### Architectural Review Board Staff Report

**Location:** 1791 Clarkson Road – Clarkson Square Adj. Lot 1

**Description:** **Clarkson Square Adj. Lot 1:** An Amended Architectural Elevation, Landscape Plan and Architect’s Statement of Design for a retail building, zoned “C-8” Planned Commercial located on the northwest corner of Baxter Road and Clarkson Road.

**RE: ARB Comment Letter – 1791 Clarkson Road – Clarkson Square Adj. Lot 1  
Project No. 23525**

(A) GUARD RAIL DETAIL  
 (A) SCALE: 3/4" = 1'-0"

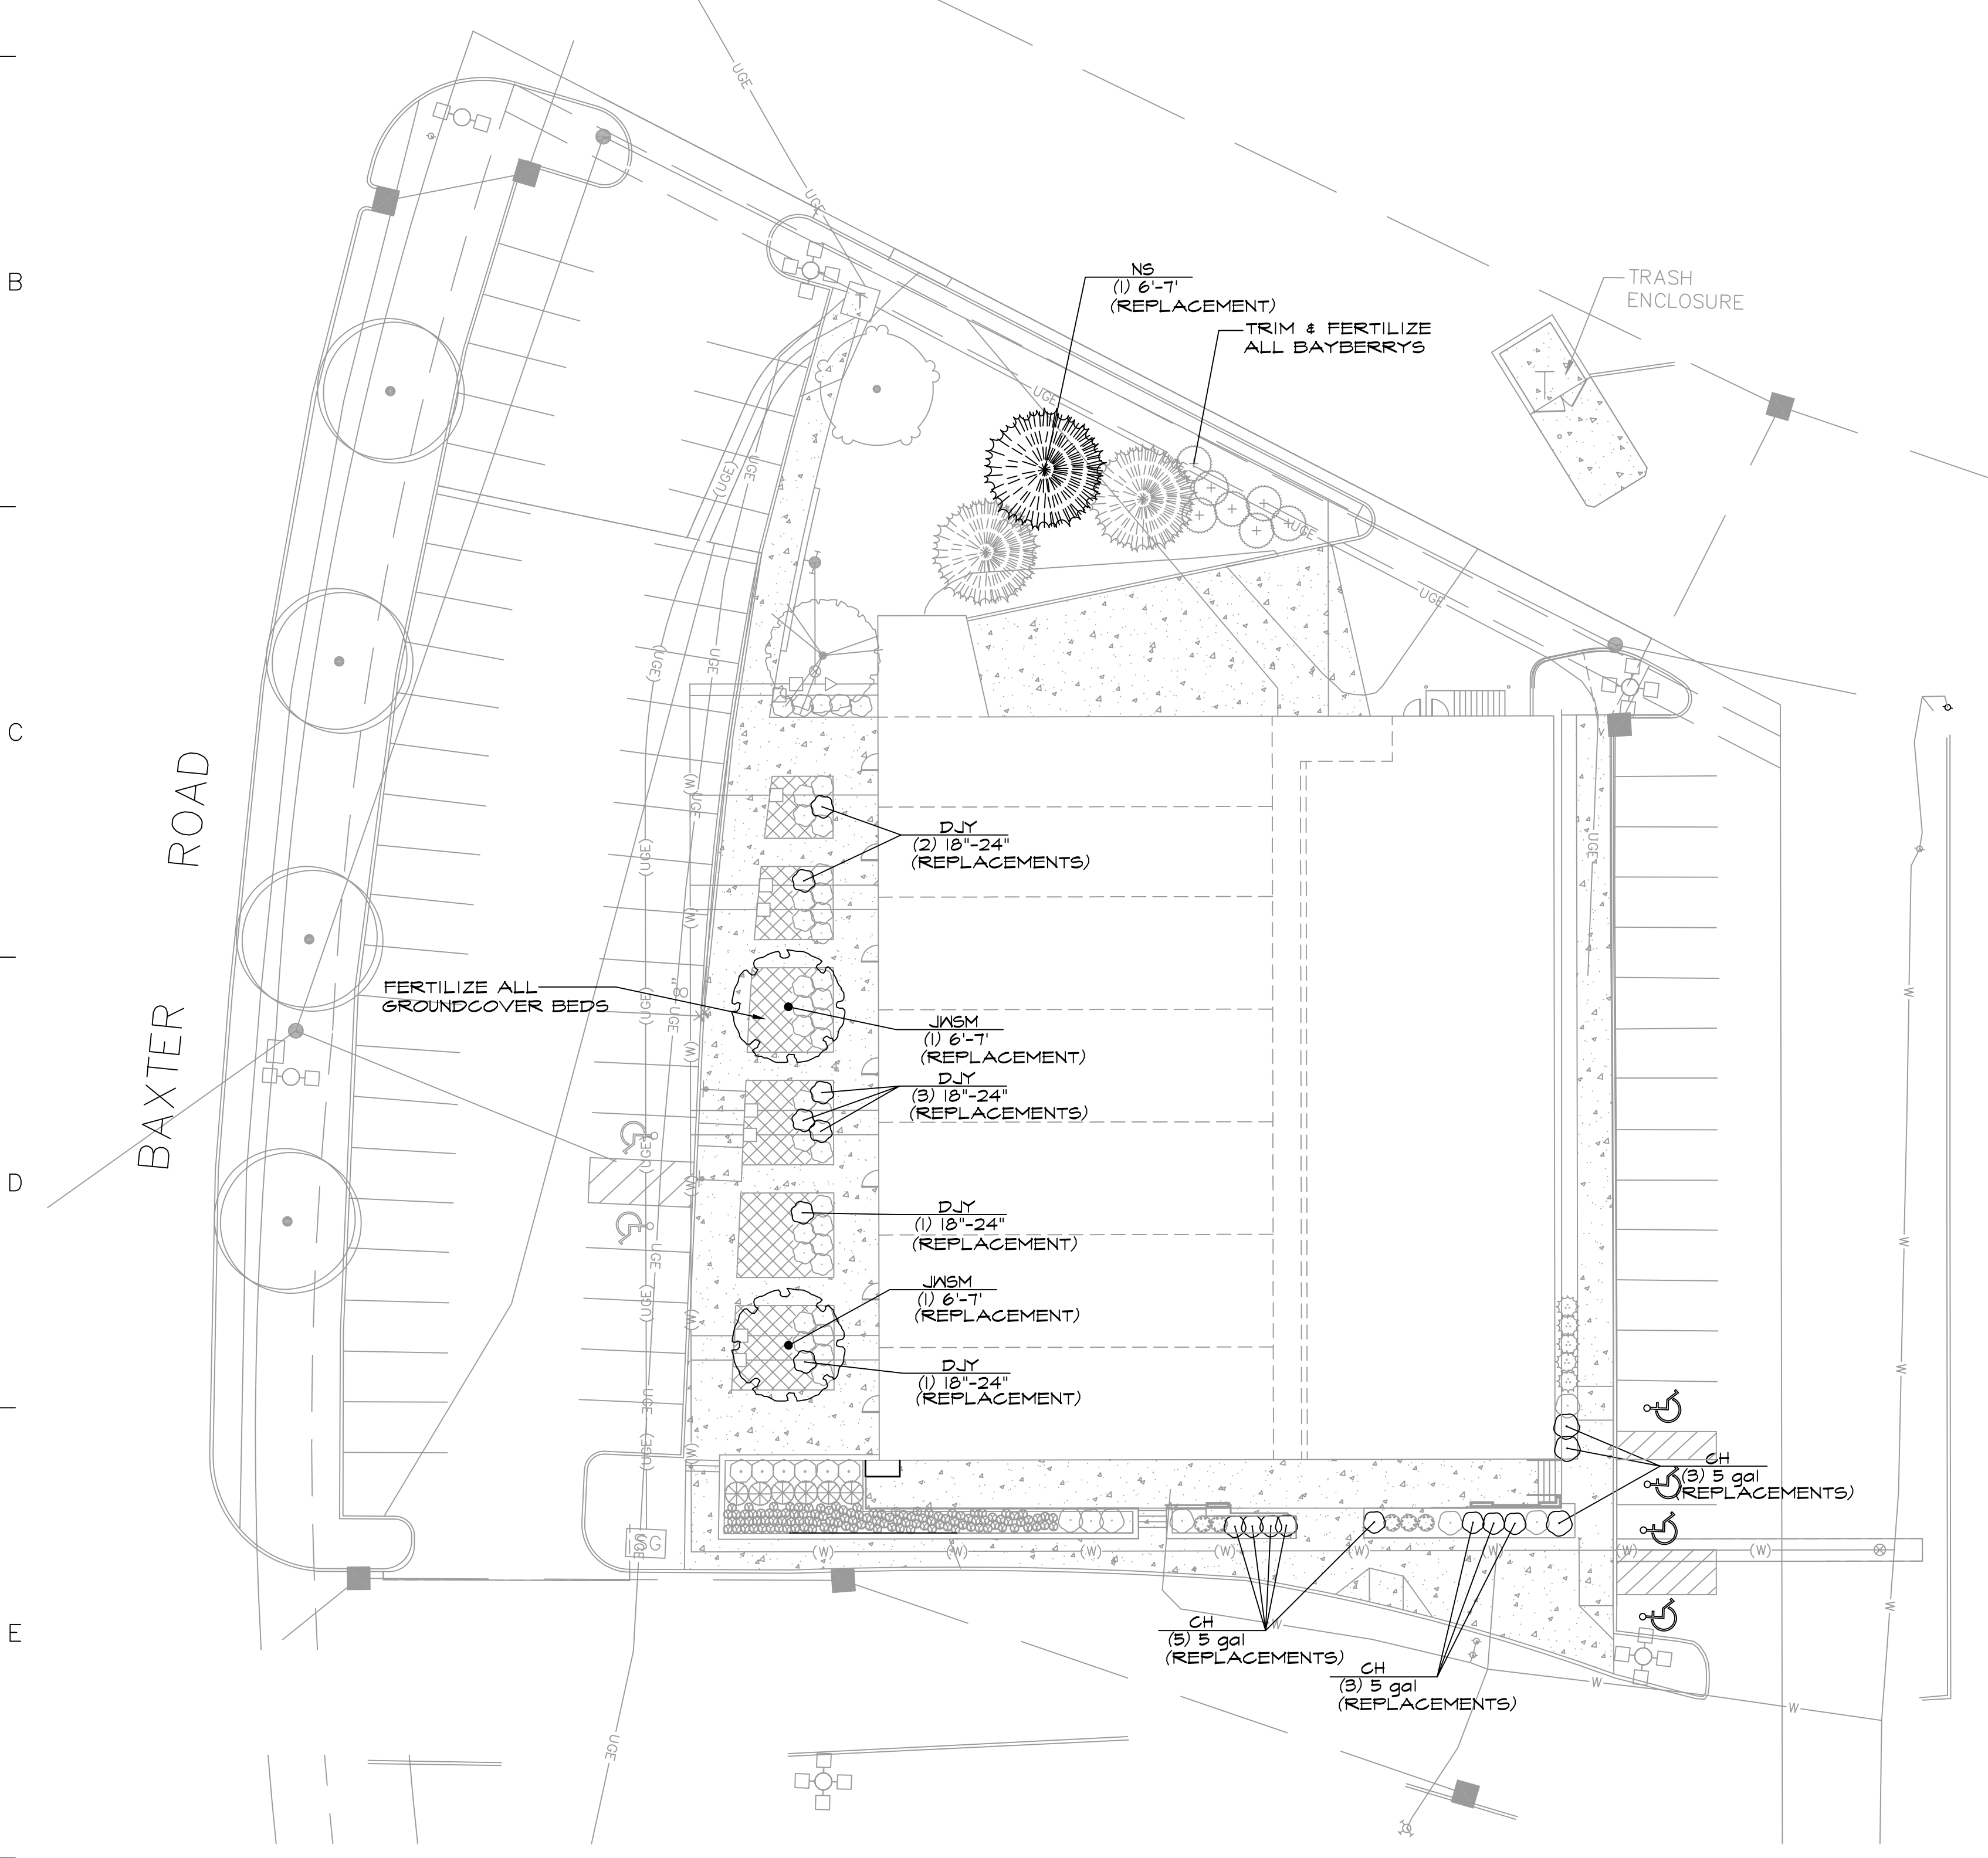
1. Provide the details of the proposed railing and retaining wall for extended porch.  
*It is our intent to provide the railing and extension of the existing porch to match the existing construction. Attached please find details from the original project that will be duplicated in the project, should you find them to be acceptable.*
2. Remove all signage from renderings and elevations.  
*Per the attached revised documents, we have removed all new signage from the elevations and rendering.*
